October 14, 2004

**Notice of Proposed Rulemaking
Federal Motor Vehicle Safety Standards; Side Impact Protection;
Side Impact Phase-In Reporting Requirements
Docket No. NHTSA-2004-17694**

Figure A-1 - Top and Side Cross-Sectional Views of FMVSS 214 (left) and IIHS (right) Barriers; All Measurements are in Millimeters

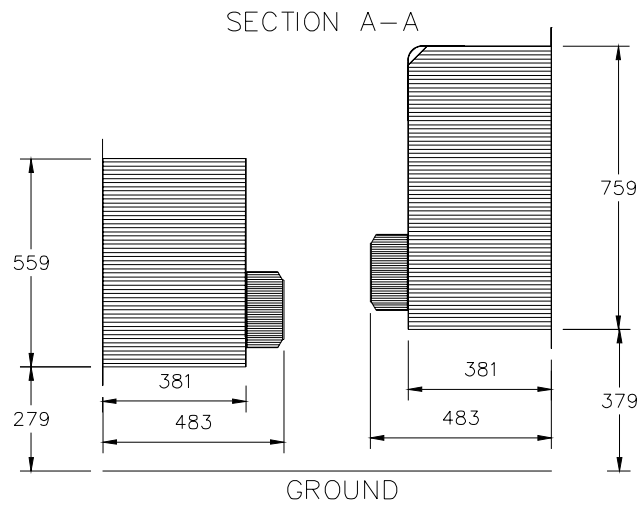
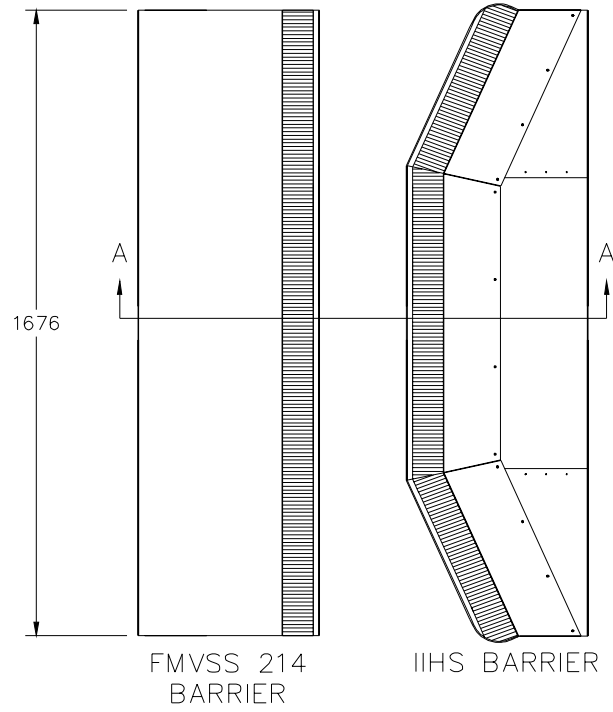
The IIHS barrier design is based on the FMVSS 214 barrier, but it is raised 10 cm from the ground and made 20 cm taller; this makes the IIHS barrier's top surface 30 cm higher than that of the FMVSS 214 barrier. The ride height of the IIHS barrier's bumper element is aligned closely with the lower edges of SUV and pickup bumpers measured at the time the IIHS barrier was designed (Arbelaez et al., 2002a). In addition to the changes made to the side view of the IIHS barrier, the front profile was contoured in the overhead view with simple 24.5-degree chamfers to represent the curved bumper geometry observed in the SUVs and pickups. A side-by-side illustration of the FMVSS 214 and IIHS barriers is shown in Appendix A, Figure A-1.

Because of this widespread acceptance and because the IIHS barrier better reflects the types of vehicles increasingly likely to cause serious injury in side impact collisions, we urge the agency to replace the now long out-of-date NHTSA MDB with the IIHS barrier for this rule. Rarely does such an opportunity for harmonized advancement of vehicle testing standards present itself. If the agency does not take this opportunity to improve the barrier and if it decides to accept less biofidelic dummy options (discussed next), it is difficult to see what benefits will accrue from the additional MDB tests that have been proposed.
